Items received during
Public Comments
On MCHD

11/8/18 PC Meeting

TRINITY COMMUNITY HEALTH CLINIC
MOUNTAIN COMMUNITIES
HEALTHCARE DISTRICT
MEAVERVILLE, CA.

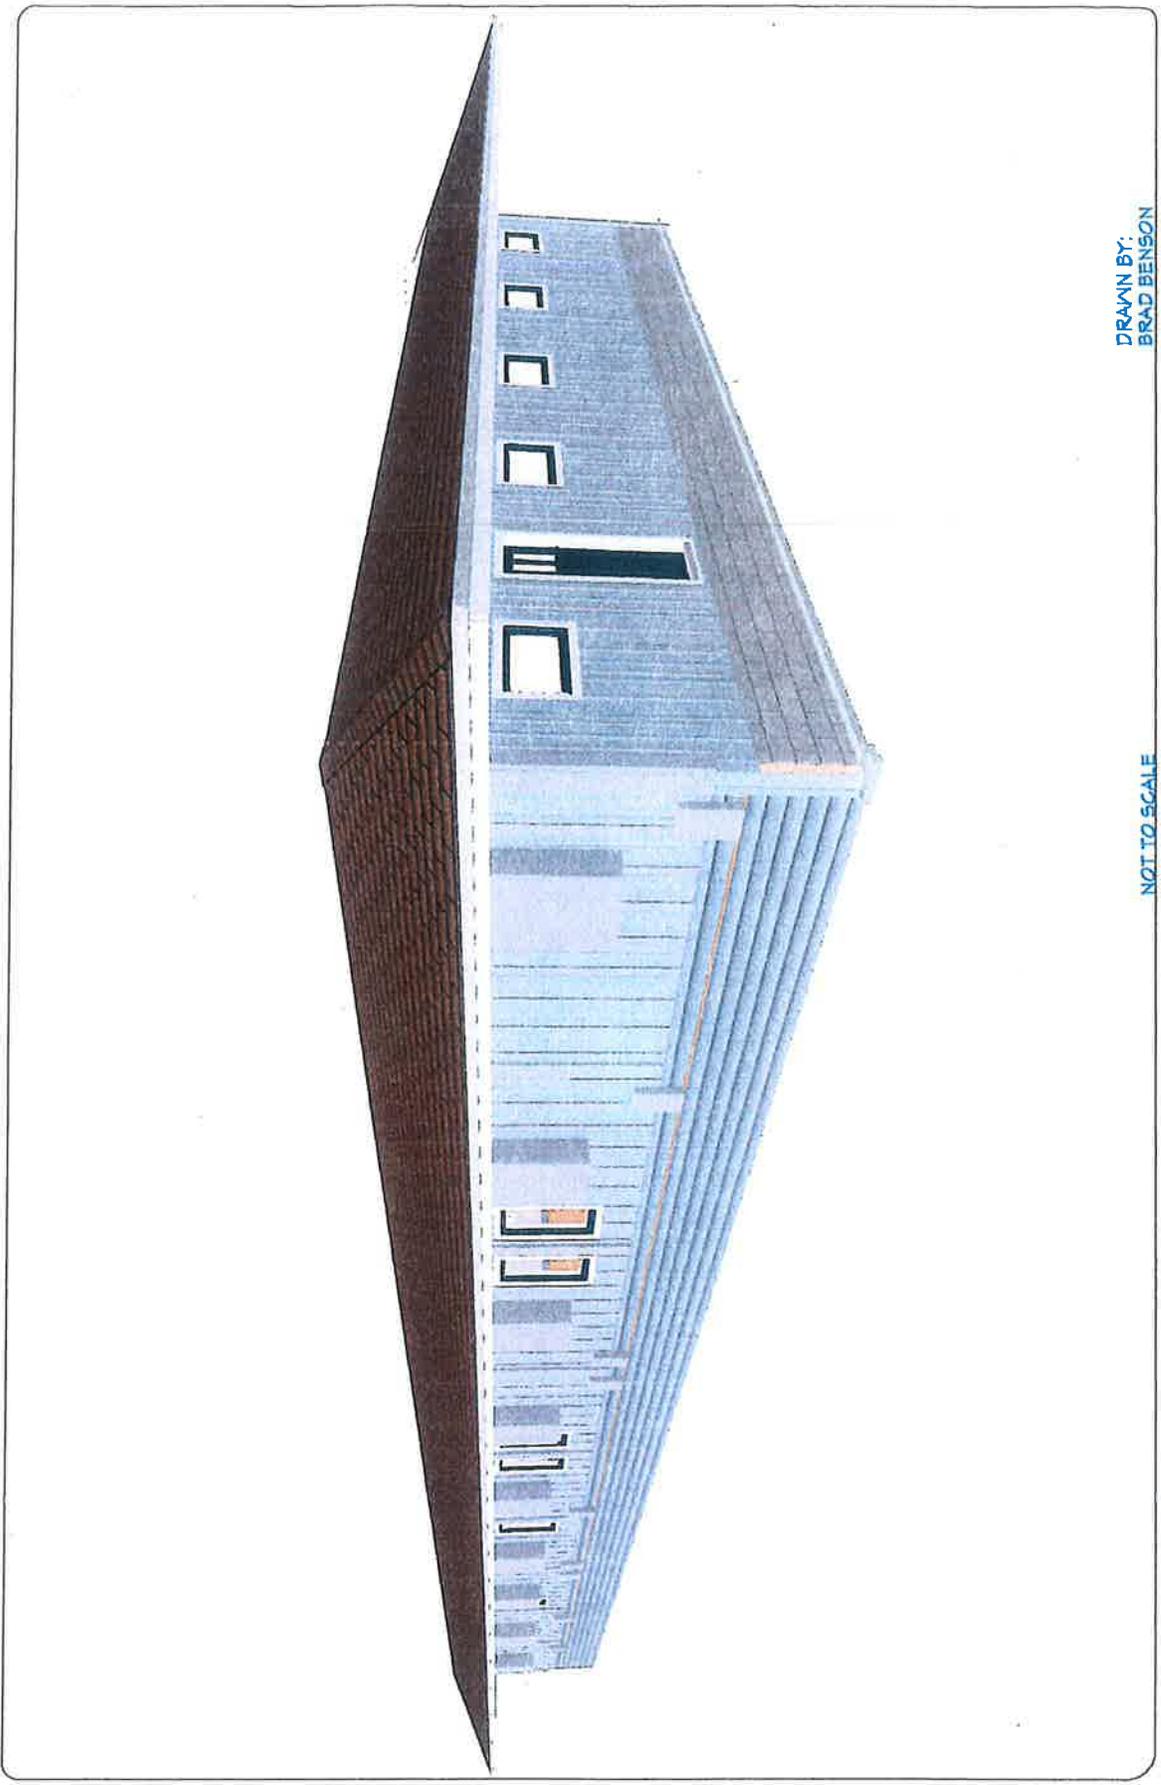
1. Remove HVAC units and install one unit on hospital side for entire building. Or turn buildings around as they should have been in the first place to protect historic side of Taylor St. Noise level to neighbors across street and historic ascetics unacceptable.

2. Full panel fence from Taylor St. to Garden Gulch to separate merged parcels from residential parcels to the South. We suggest an 8ft. metal fence, rock or concrete. A fence with little to no maintenance in the future.

3. Since the footprint of the modular is supposedly smaller, then no entrance or exit is necessary on Taylor St. Restructure turn around in parking lot, and all traffic can go on and off Garden Gulch. Taylor St. is not a lined street and unsafe for people to enter that street. Since the doors to the clinic are supposed to be off the current clinic, then any emergency vehicles will come to the front, and is no longer an issue to exit onto Taylor St.

6. Water run-off catchment should be placed on the parcel that was merged into hospital property, not overlapping on the residential parcel next to it. Yes the hospital also owns that property, but this project was to stay on the parcel it was annexed to. Then, if a future sale of that residential property were to happen, there will be no need to adjust that line. Also, since we are recommending a fence to separate the project from the residential area, this catchment needs to be on the property it belongs to.

7. We also want clarification that no parking is going to be allowed on that back parcel. At this time they are using it for dirt piles and equipment parking for the project, but this back area is not a part of the merge, it is a part of the residential piece. We want to make it clear that this piece will remain a residential parcel in the future.
